AMENDMENTS TO THE DRAWINGS:

REMARKS

Applicants submit this reply in response to the non-final Office Action mailed November 6, 2006, the period for response being extended through April 6, 2007, with the concurrent filing of a petition for two-month extension of time and payment of the requisite fee. Claims 1-12 are currently pending, of which claims 1, 11, and 12 are independent. In this response, Applicants have amended claims 1-12 and have canceled unelected claims 13-26 without prejudice or disclaimer. Applicants have also amended FIGS. 1-3 and 5-6 and the Abstract in accordance with the Examiner's required changes.

FIG. 1

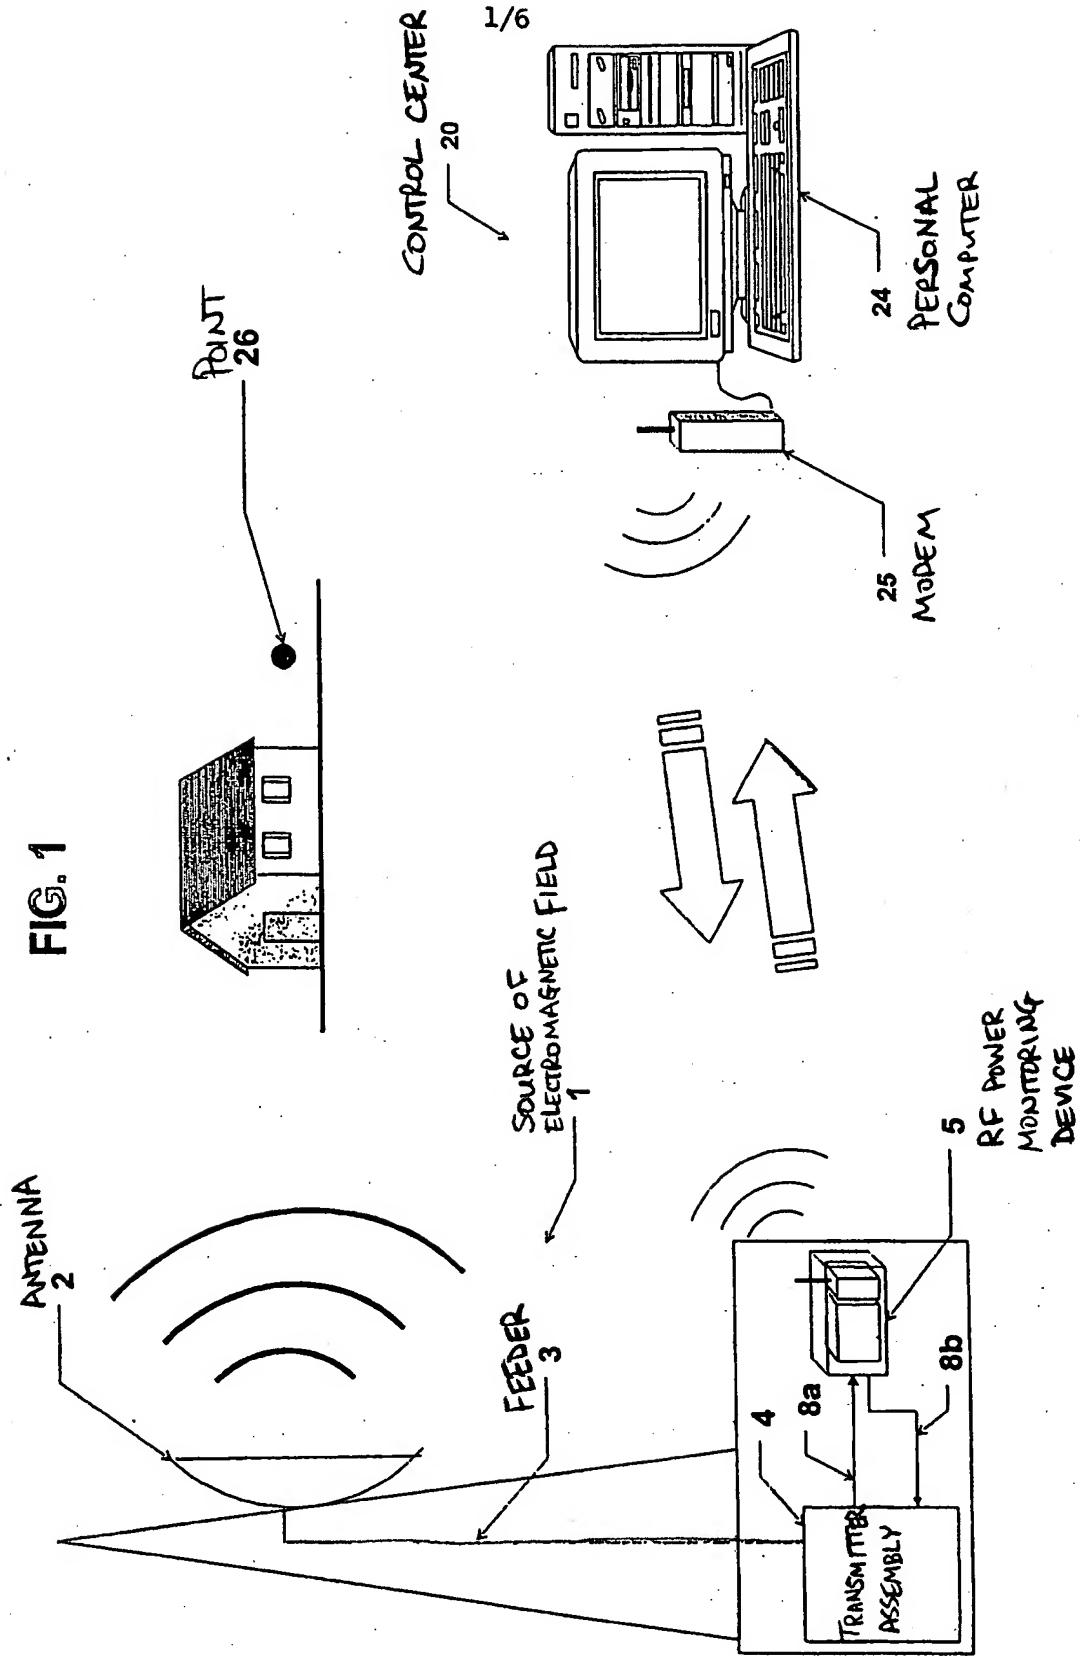
The Examiner objected to FIGS. 1-3 and 5-6 because certain empty boxes require descriptive labels. In response, Applicants have prepared the attached Replacement and Annotated drawings sheets including the Examiner’s requested changes. Specifically, Applicants have added descriptive labels to more clearly identify elements in FIGS. 1-3 and 5-6, thereby obviating the pending drawings objections.

The attached sheets of drawings include the Examiner's requested changes to FIGS. 1-3 and 5-6. Specifically, Applicants have added descriptive labels to more clearly identify elements in the figures. Applicants attach Replacement Sheets including the corrected figures and Annotated Sheets showing where labels have been added.
